REVIEW OF APPLICATION FOR CERTIFICATION BY THE LOW IMPACT HYDROPOWER INSTITUTE OF THE BRADDOCK LOCKS AND DAM HYDROELECTRIC PROJECT

Prepared by Patricia McIlvaine
June 3, 2022

Figure 3 – Planned Location of the Braddock Project

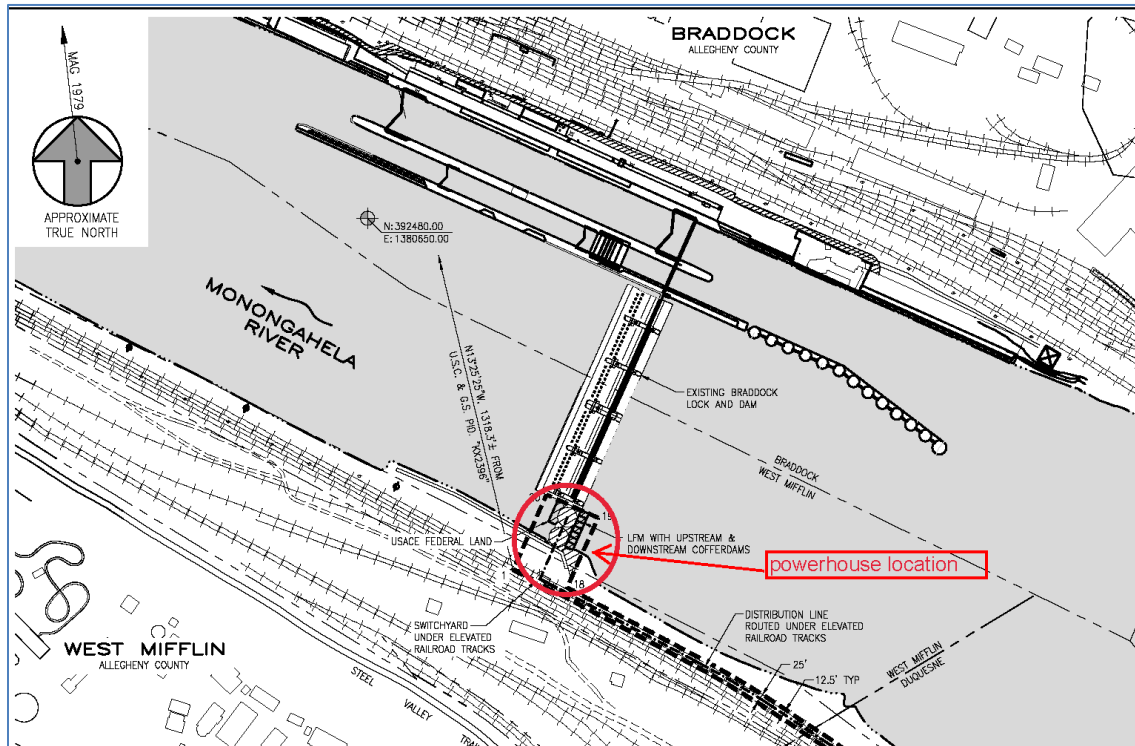
- 1) Please provide a diagram or sketch which shows the location of the proposed hydropower project at this ACOE dam.
